BRITISH GLIDING ASSOCIATION

BGA TECHNICAL COMMITTEE

TECHNICAL NEWSHEET TNS 3/4/94

Hotellier Ball and Swivel Joints

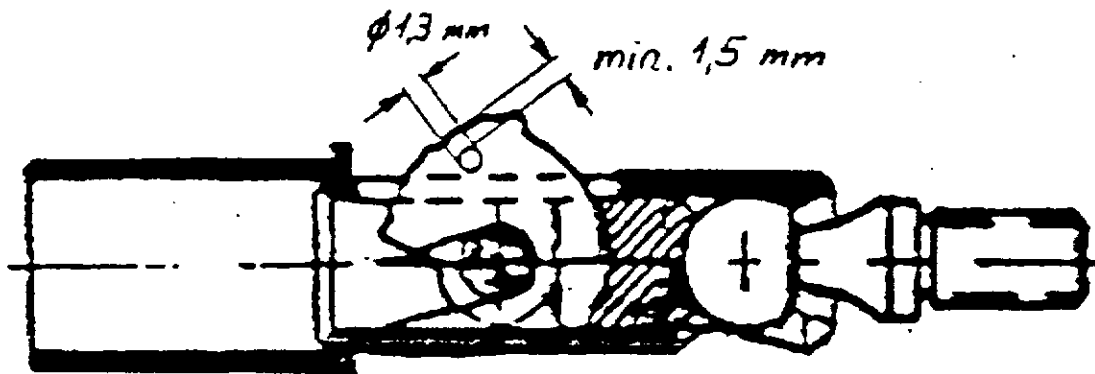
The swivel is to be slid completely over the ball on the rod with the locking cam pulled back. During locking the locking cam moves back slightly so that in a correct joint the hole on the averted edge of the locking cam becomes visible.

The safety pin is to be inserted in this hole thus securing the ball and swivel joint.

Unsecured ball and swivel joints may open automatically in flight !

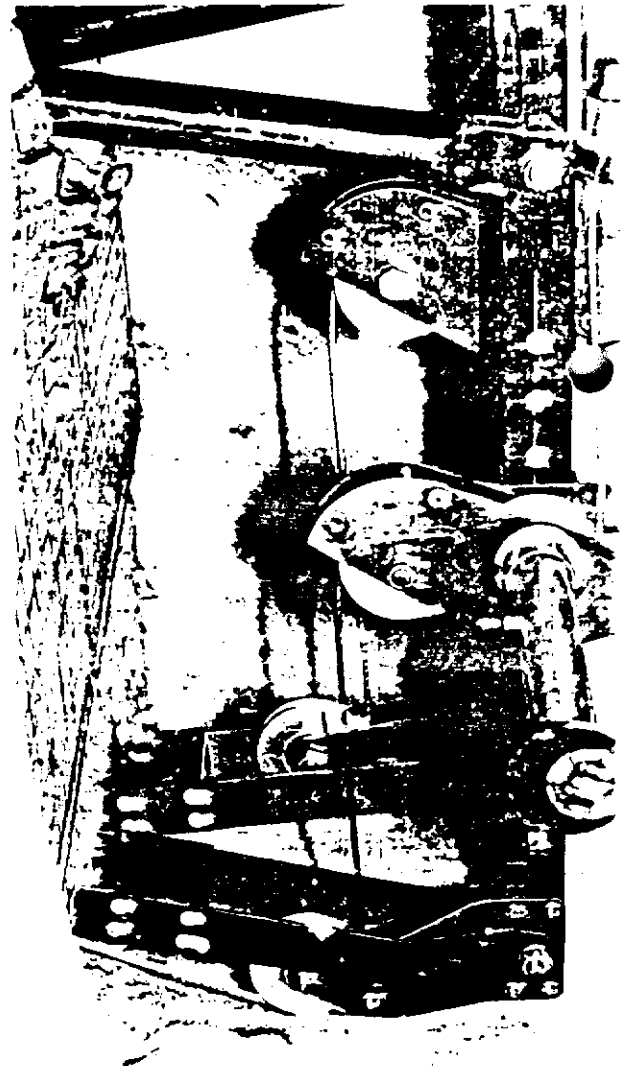
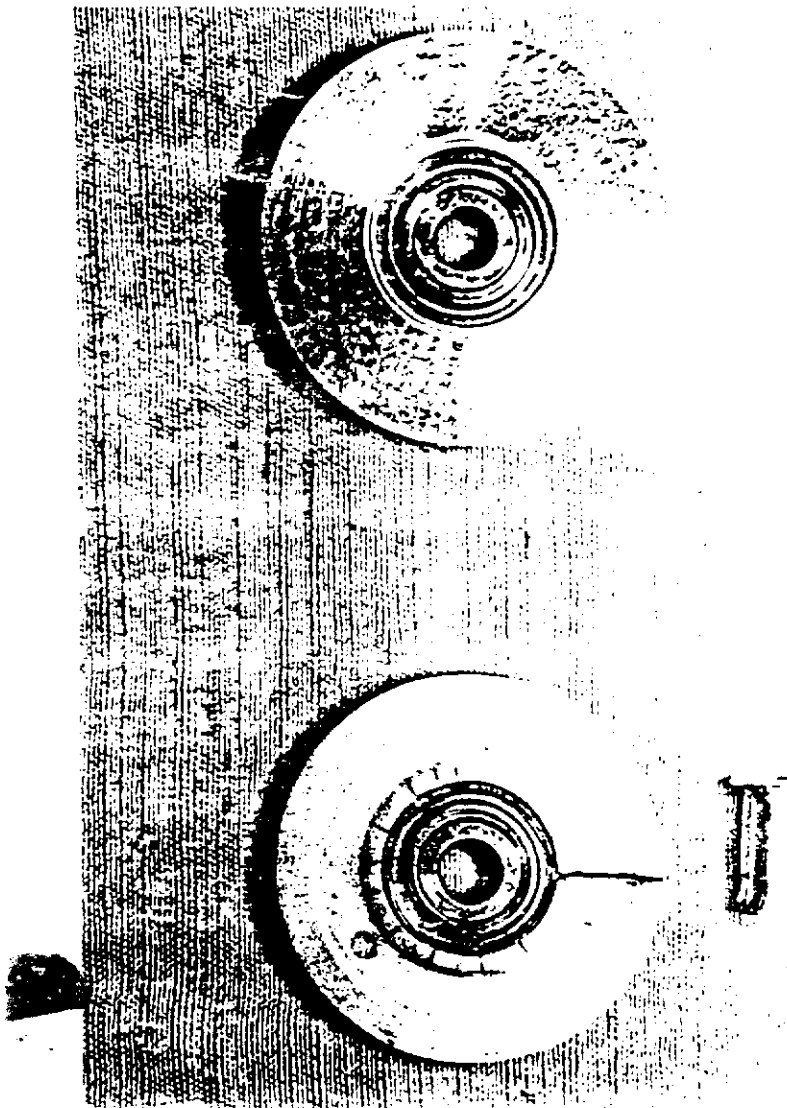
Drill the hole \emptyset 1,3 mm with the ball correctly inserted so that one edge of the hole is level with the main body of the joint and on the other side at least 1,5 mm of material is left (see also the following sketch).

Warning: When working on the joint please see to it that no borings get in between the ball and the socket.

- 1) Safety pins (e.g. L'H 140-31 made by Hotellier) have to be retrofitted. In case the locking cams have not already been fitted with holes (\emptyset 1,3 mm) these holes are to be drilled within the framework of this AD.

BULLETIN No. BE-0002/03 "JUNIOR"

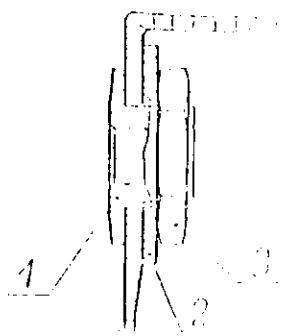
On the first production series of the SZD-51 "JUNIOR" gliders, the premature appearance of the play on the fitting of dove-shaped sleeve has been found. This Bulletin allows to remove this fault.

The substitution provided by sleeve should be executed. The tin wall strengthened and the sleeve fixed with nut installed.

1. Put the fuselage on the supports on its left side, the plane of glider symmetry should be horizontal.
2. Cut the auxiliary opening of about 60 mm diameter in the righthand covering.

3. Using the speed rotation milling-cutter inserted through the auxiliary opening remove the sleeve position securing indentations inside the sleeve. Remove the washer and sleeve.

4. Clean the tin wall around the hole for the sleeve together with the inner ledge folded on the rib. Take care the hole to be not damaged. In case the external layers of the composite are torn off remove this failure.

5. Complete the eventual wall diminations, put the inside strengthening of 3 x 92125 "X" fabric about 60 x 70 mm folded on the ledge.
6. After the initial curing drill the ϕ 14 hole and then ream for ϕ 10 H7 axial with the old hole.

7. Wash the sleeve, washer and nut with the extraction gasoline. Insert the sleeve into the wall using the composition thicked with screw 11, put on the washer, screw in the nut and secure it by potting in four places.

8. Clean the tin inside, glue in the auxiliary opening in the covering area to the Repair Manual. Apply the local post-curing proper to the resin used (for Ep-52 in 60 °C temperature during 10 hours).

GADRINGER
HARNESSES

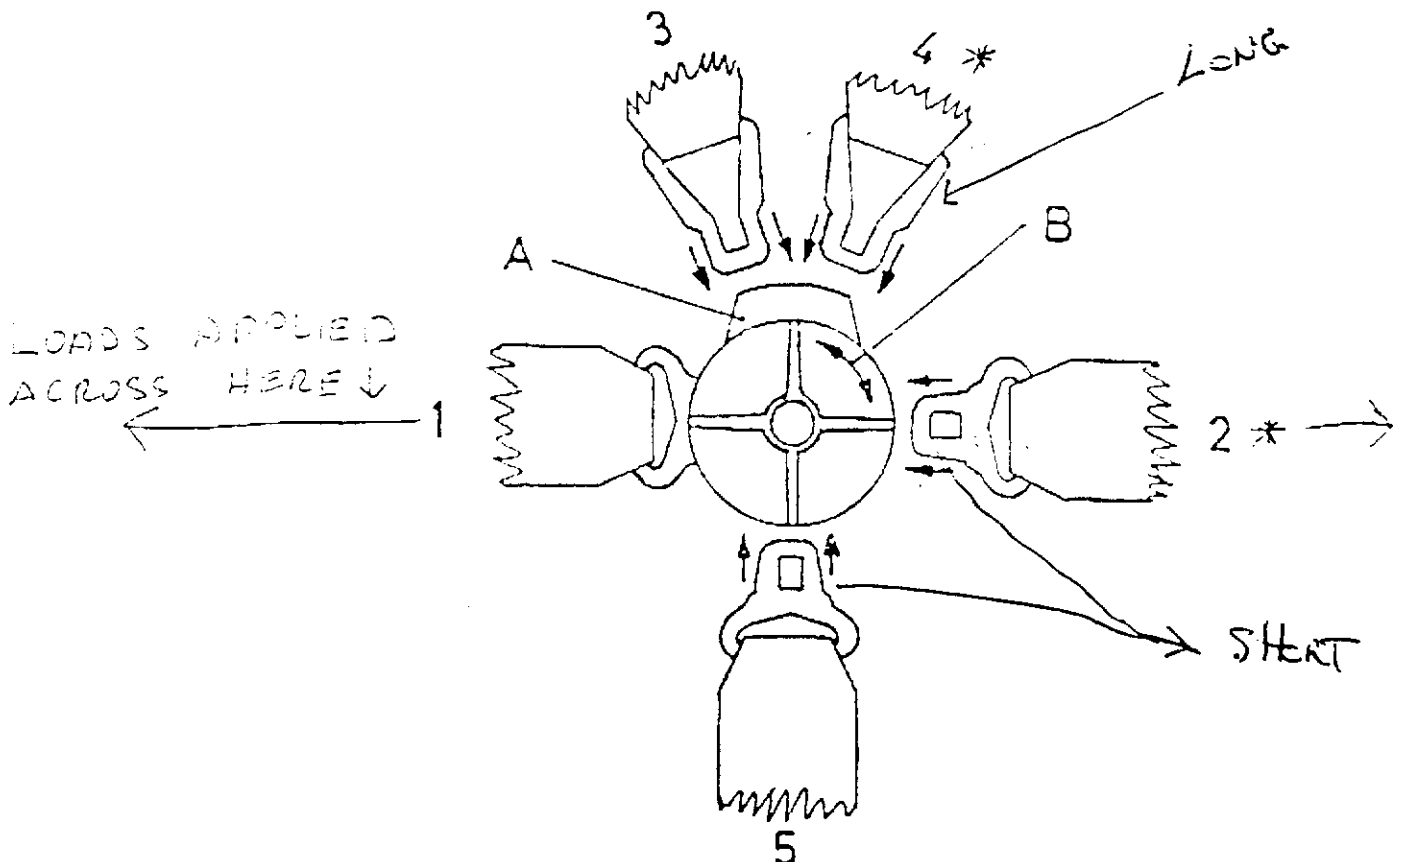
- 1.5. Gadringer Harnesses must be installed with the straps orientated as illustrated. Incorrect assembly will cause the straps to let go under negative loadings. (London Sailplanes).

Ignition unit of ROTAX engine 912 A

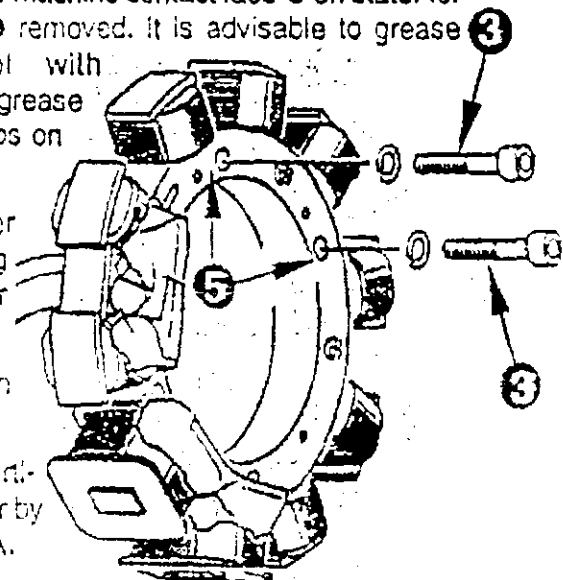
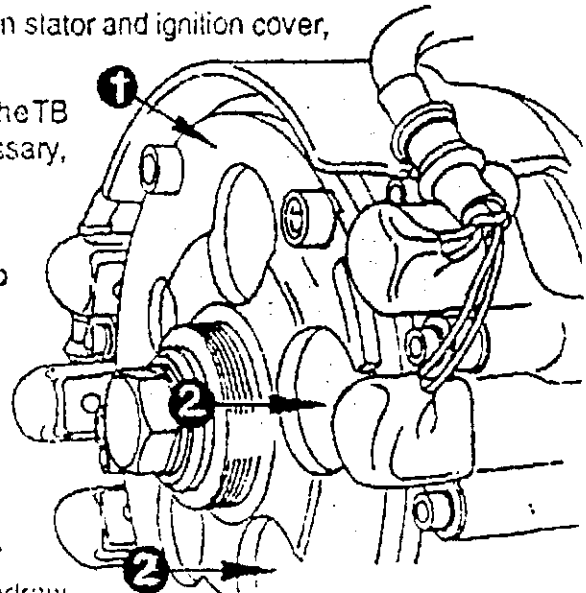
Subject: As known from experience, inadequate ground connection could arise between stator and ignition housing on the engine type 912 A.

Reason: Isolated formation of corrosion between stator and ignition cover, respectively at attachment screws.

Disconnect battery. No need to withdraw magneto housing ① with magneto ring. Remove at least 2 of the 4 Allen screws ② and lock washers for stator attachment via the openings ② in the magneto housing.

Use spot-facing cutter ④ or similar tool to machine contact face ⑤ on stator for the screws ② removed. It is advisable to grease cutting tool with Lithium-base grease to collect chips on

Refit screws M5 along with lock washer and tighten to 6 Nm. To ensure lasting ground connection, treat contact faces for screws with Lithium-base grease.
